Project	IEEE 802.16 Broadband Wireless Access Working Group < http://ieee802.org/16 >	
Title	CTS allocation for IBS and OBS	
Date Submitted	2006-02-28	
Source(s)	Wu Xuyong, Zhao Quanbo, Pan Zhong, Huawei Huawei Industrial Base, Bantian, Longgang, Shenzhen 518129 P.R.C	Voice: +86-755-28971677 Fax: +86-755-28975523 wuxuyong@huawei.com
Re:	80216h-06_005: Call for Comments and Contributions: IEEE 802.16 License-Exempt Task Group (2006-02-06)	
Abstract	ICTS is for the BSs which does not have repetitive scheduled CTS. OCTS is periodical scheduled to the BSs in community. This paper is discussion the usage, timing and scheduling method of these CTS.	
Purpose	Define the scheduling process and parameter of CTS in one community.	
Notice	This document has been prepared to assist IEEE 802.16. It is offered as a basis for discussion and is not binding on the contributing individual(s) or organization(s). The material in this document is subject to change in form and content after further study. The contributor(s) reserve(s) the right to add, amend or withdraw material contained herein.

CTS allocation for IBS and OBS

Huawei Technologies Co., Ltd.

figure hxx. format of ICTS/OCTS allocation MAP

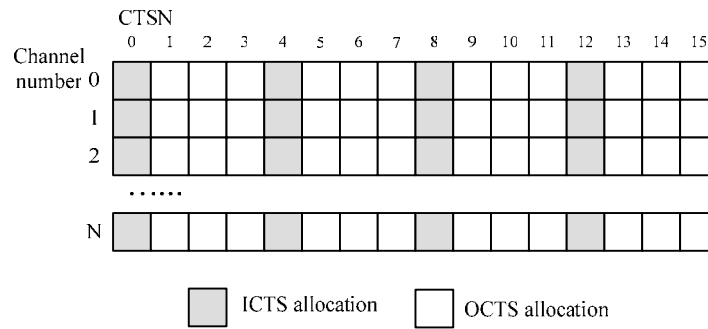
Change section 15.3.1.1.1 as indicate:

15.3.1.1.1 Interference Identification & Resolution via CTS Detection

Downlink CTS is use by the BSs to broadcast signaling to the neighbor systems. These signals is used for Interference identification and resolution. In order not to collide with the neighbor, the coordinated community should prevent neighbor BSs to use the same CTS.

*CTSN is used to schedule the CTS in neighborhood, CTSN is periodical synchronized number of CTS. The period of CTSN is the length of OCTS cycle. $CTSN = FN(\text{frame number of the frame after CTS}) / N_{CTSinv} \text{ mod}(N_{ICTS_Cycle} * N_{OCTS_Cycle})$.*

There was one ICTS for IBS in an ICTS cycle, and the rest CTS is leave to OBS as OCTS. Every OBS need to get its OCTS allocation in one OCTS cycle, which is formed by multiple ICTS cycle so that IBS can get more opportunity then OBS.

*There is N_{OCTS_Cycle} ICTSs in one OCTS cycle, and the rest CTS could be allocated to $((N_{ICTS_Cycle} - 1) * N_{OCTS_Cycle})$ OBSs. Notice if there is N channel which could be used for 16h system in one area. There will be $N * ((N_{ICTS_Cycle} - 1) * N_{OCTS_Cycle})$ OCTS opportunity for OBSs.*

figure 2. example of CTS allocation MAP in one BS's database

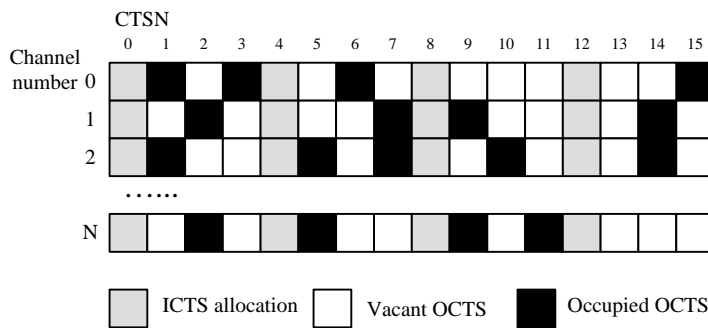
Here is an example of the CTS allocation MAP of one BS during his initialization phase by collecting the CP message information from his neighbors. Assume this BS have choose channel 0 as its working channel, it can pick any one of the CTSN 2,5,7,9,10,11,13,14 as its OCTS allocation number. Every BS have its own CTS allocation map indicating the current situation of CTS occupancy by the neighbors in the working channel and potential neighbors in the potential working channel. The CTS allocation MAP table of potential working channel will be used when BS move to another channel in cases. The CTS allocation MAP of the BS should be updated in time when any changes have been informed by its neighbors in the working channel and potential neighbors in the potential working channel.

In the OCTS mapping table, every neighbor in working channel or potential neighbor in potential channel is mapped to one OCTS allocation, every OCTS allocation will indicate its occupant or vacancy. By inquiring the mapping table of the OCTS allocations to the BSs, one BS can recognize the source of the interference or signaling in each OCTS allocation.

The initializing BS use the OCTS allocation table to find out its neighbors in the working channel. By the contact information it acquired from the CP message, the IBS will than use CP message to negotiate for interference resolution with its neighbors.

Figure h9—Timing of Coexistence Time Slot

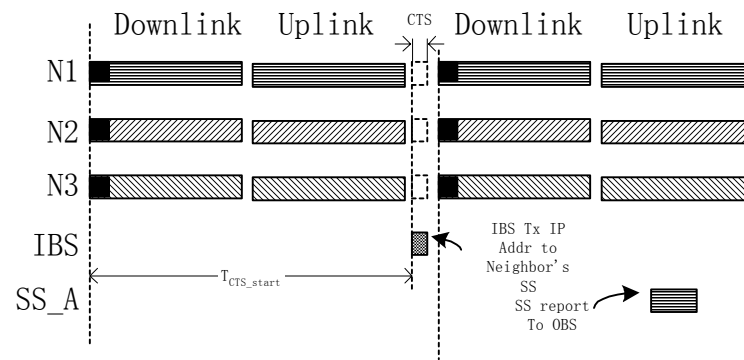
Change the section 15.2.1.1.3 as indicate:

15.2.1.1.3 Coexistence Time Slot

CTS (Coexistence Time Slot) is predefined time slot for the coexistence protocol signaling purpose, especially for the BS to contact its coexistence neighbor BS through one or more coexistence neighbor SSs in the common coverage area. For the Initializing BS, periodical CTS called ICTS (Initializing Coexistence Time Slot) is appointed specially used by IBS to contact its neighbor OBS. Buy coordinate with other BS, the IBS will get its periodical OCTS (Operating Coexistence Time Slot) which is allocated only for this BS, and start the operating stage, hence ceased from using the ICTS.

Every CTS have its number, called CTSN (Coexistence Time Slot Number), that's a periodical number according to the time order.

~~ICTS must not be used for other purpose by all the BSs, so that it will be an interference free slot for the coexistence neighbor discovery purpose. Initializing BS (IBS) shall use this slot to broadcast its IP identifier, by sending a message and/or by cognitive radio signaling, so that the coexistence neighbor operating BS (OBS) could find the new coexistence neighbor in IP network after the SS report the message. Then the IBS and OBS begin further negotiation for coexistence protocol. After coordination with the neighbors in the community, IBS will get periodical interference free OCTSs, and become OBS, after that, it will cease to use the ICTS.~~

Not to break the downlink PDU, and to ~~prevent diminish~~ overhead of more preamble and gaps. CTS slots shall be located before RTG/TTG in TTD frame structure or before the preamble of downlink frame in FDD frame structure. To unify the location in these two kind of ~~frame duplexing frame~~, CTS slots in FDD frame shall be put into the downlink structure right before the preamble, and shall be located right before RTG in TDD frame.

Figure h12—CTS usage example—IBS broadcast IP address to CoNBR's SS

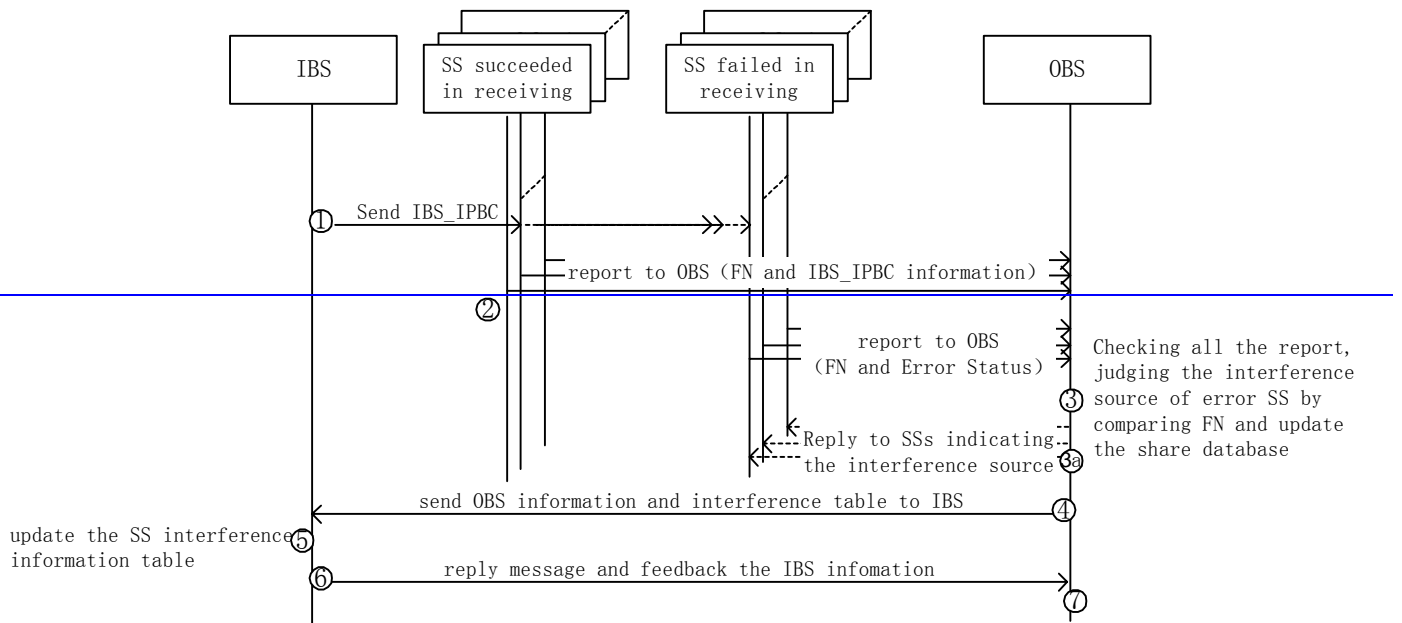
[notes: this figure moves to 15.2.1.3]
